August 17, 2017  
GO2-17-147

Subject: **COLUMBIA GENERATING STATION, DOCKET NO. 50-397  
ENERGY NORTHWEST'S NOTIFICATION OF FULL COMPLIANCE WITH  
ORDER EA-12-049, "ORDER MODIFYING LICENSES WITH REGARD TO  
REQUIREMENTS FOR MITIGATION STRATEGIES FOR BEYOND DESIGN  
BASIS EXTERNAL EVENTS"**

<b>Columbia Generating Station  Mitigation Strategies/Spent Fuel Pool Instrumentation Safety Evaluation Audit Items:  Audit Items Currently Under NRC Staff Review, Requiring Licensee Input As Noted</b>		
<b>Audit Item Reference</b>	<b>Item Description</b>	<b>Licensee Input Needed</b>
ISE CI 3.2.3.B	The licensee's proposed strategy for maintaining containment will rely on installation of the HCVS as required by Order EA-13-109. When complete, the licensee's calculations supporting the revised containment response and sequence of events timeline should be reviewed to confirm that the timeline is appropriate and that containment functions will be restored and maintained following an ELAP event.	The licensee needs to provide to the NRC staff the final configuration and calculations for the HCVS.  <b>Energy Northwest Response</b> See attached discussion.
AQ 41	The alternate strategy for Phase 2 core

**AC ELECTRICAL WIRING DIAGRAM**  
**POWER PANEL E-PP-7AZ**

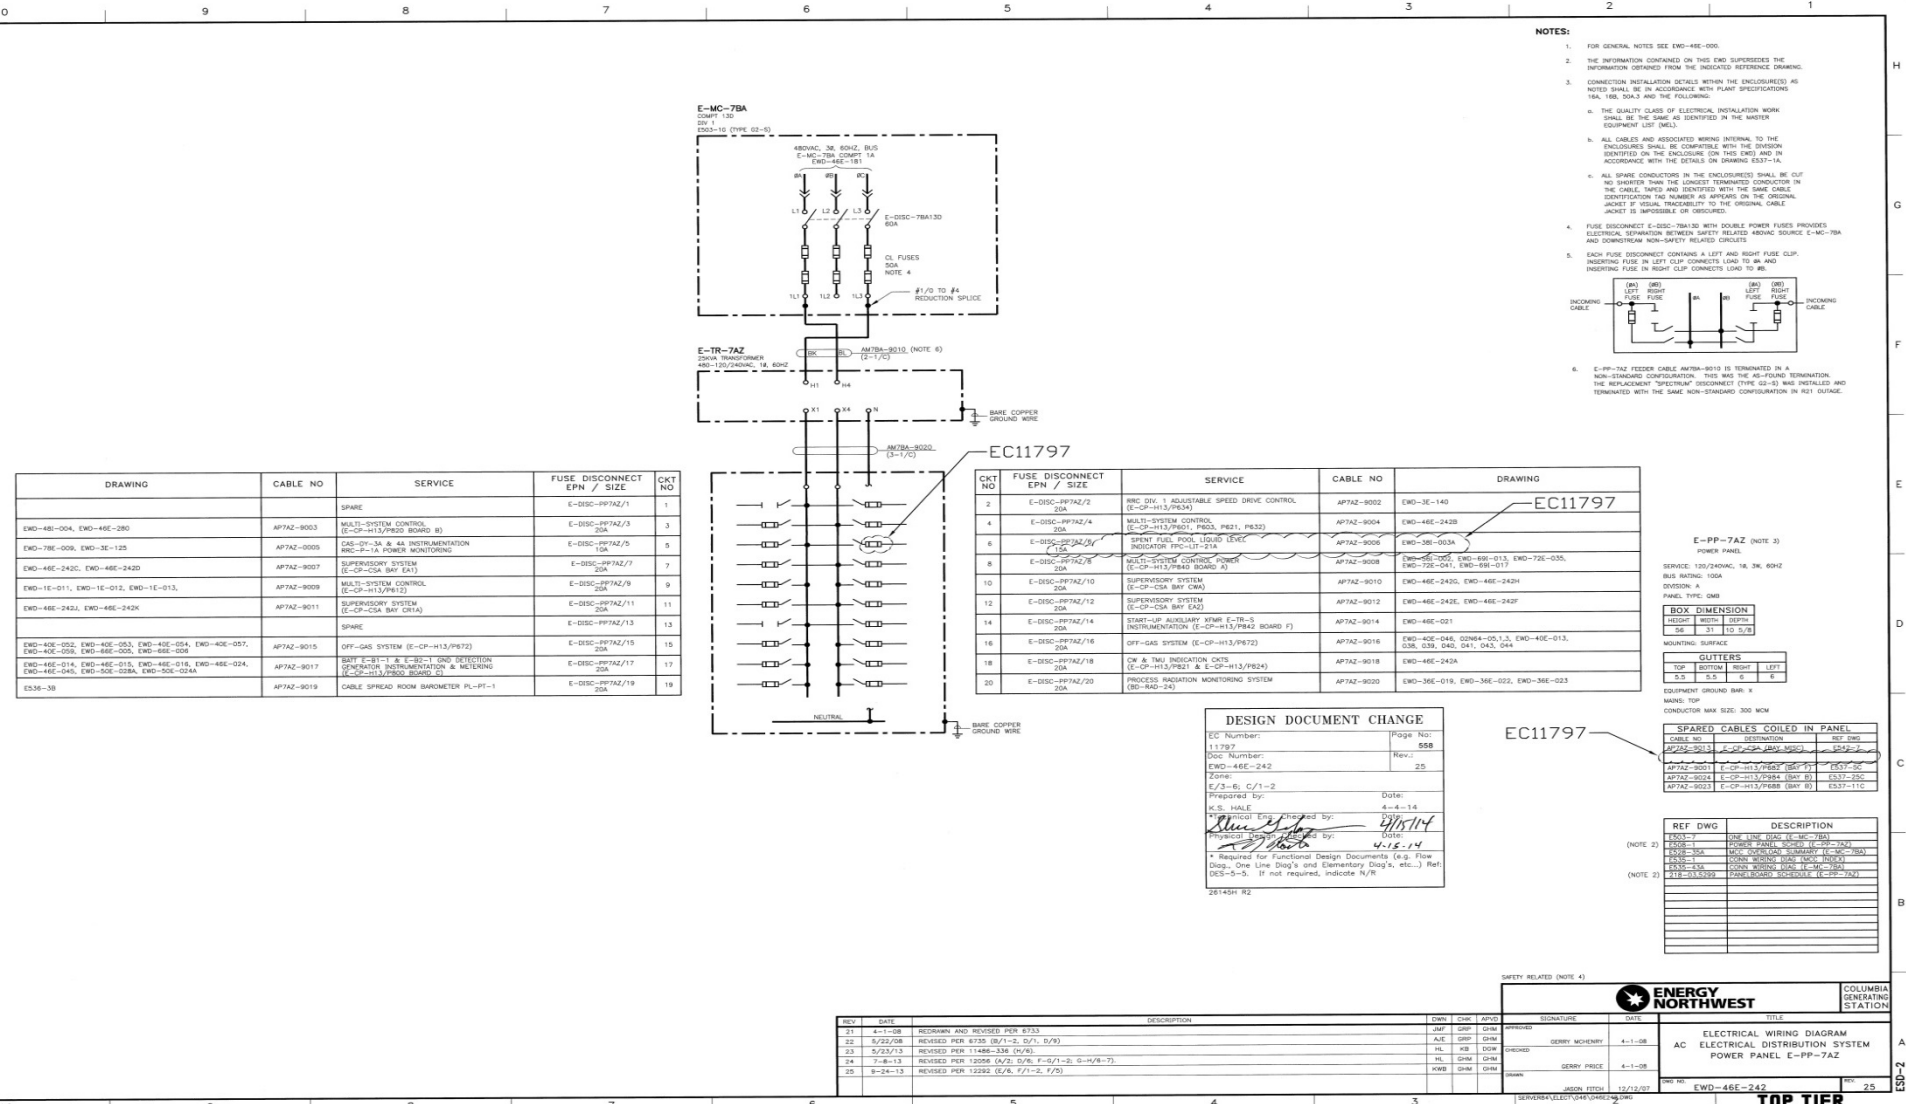
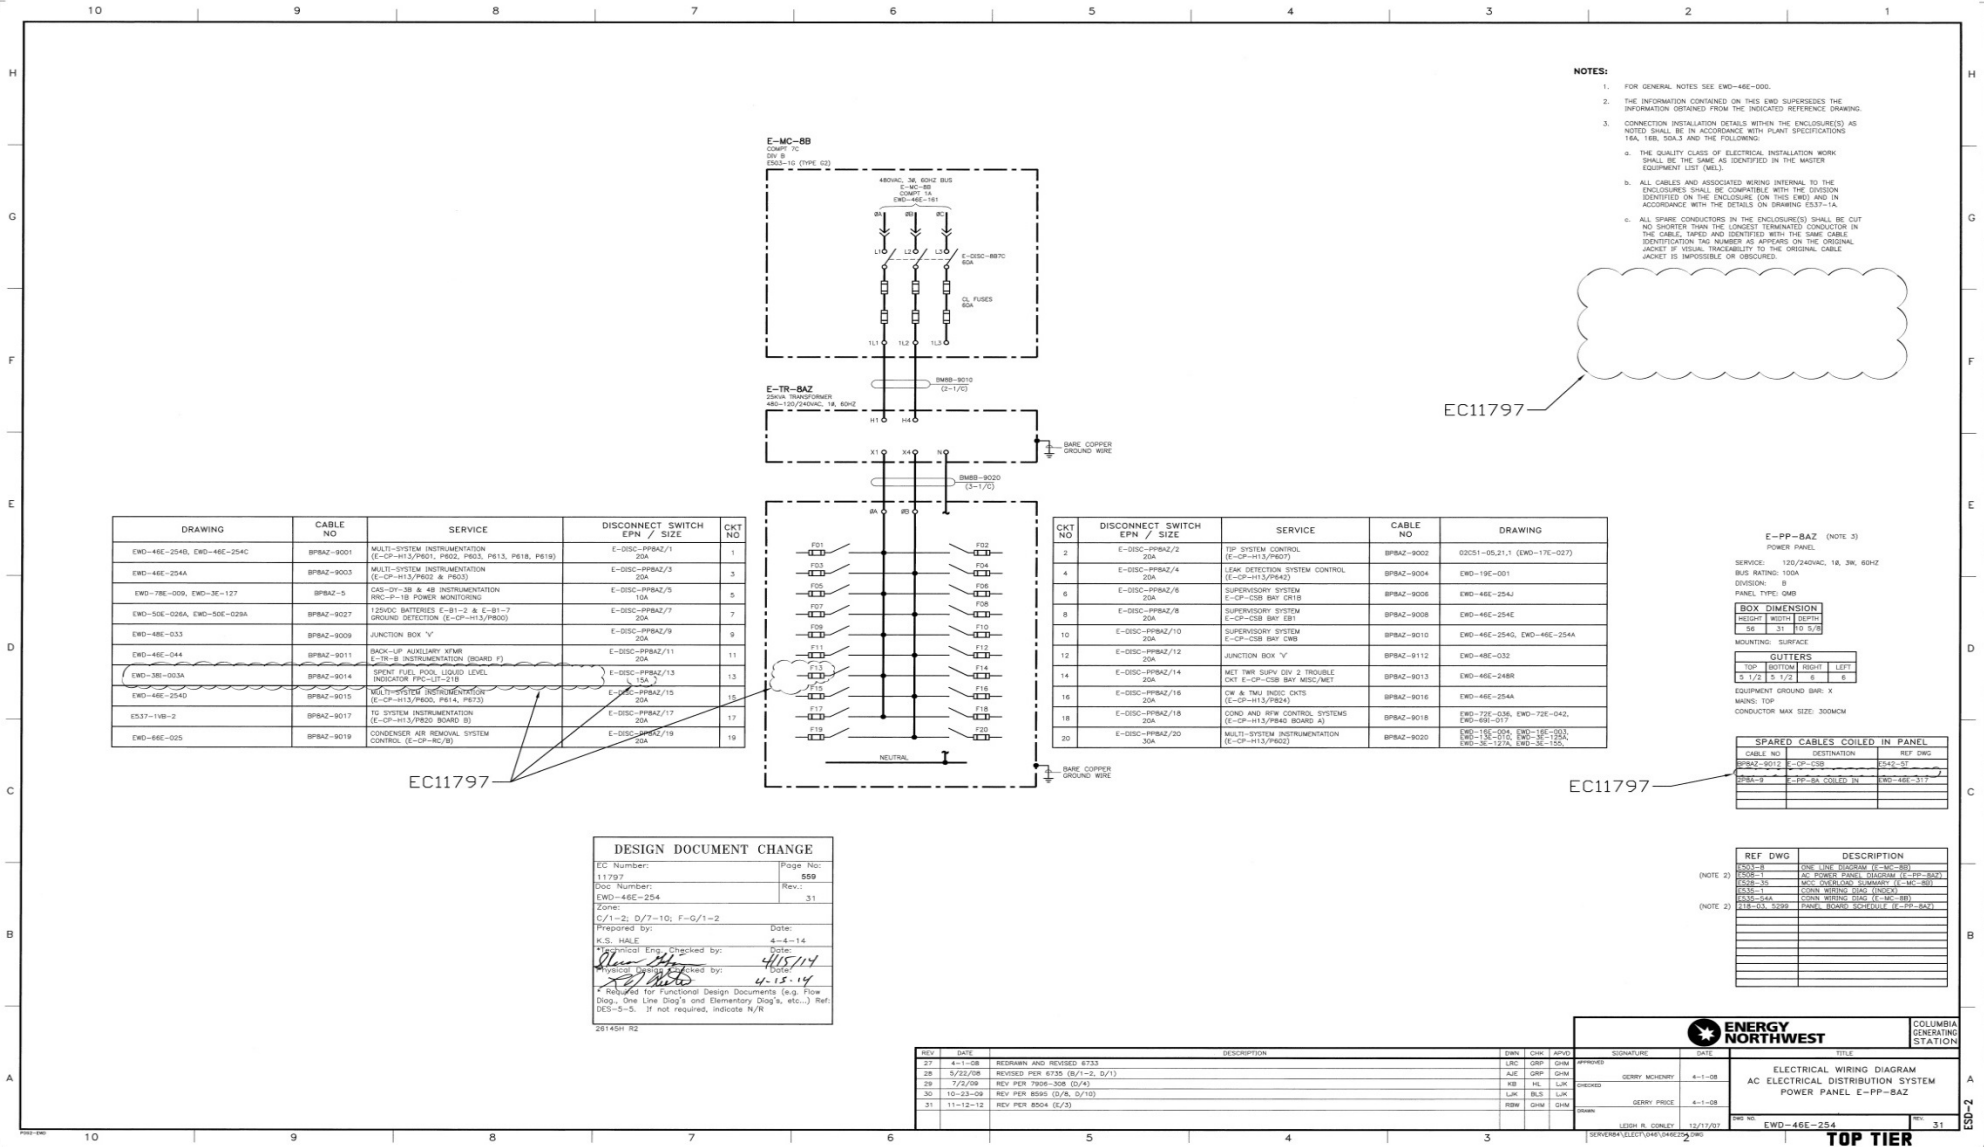
Please provide the NRC staff with the final configuration of the power supply source for each channel so that the staff may conclude that the two channels are independent from a power supply assignment perspective.

Each SFP instrument channel is normally powered from a 120/240-V ac 60 Hz plant distribution panel to support continuous monitoring of SFP level. The primary channel will receive power from a different 480V bus than the backup channel. Therefore, loss of any one 480-V ac bus does not result in loss of normal 120-V ac power for both instrument channels.
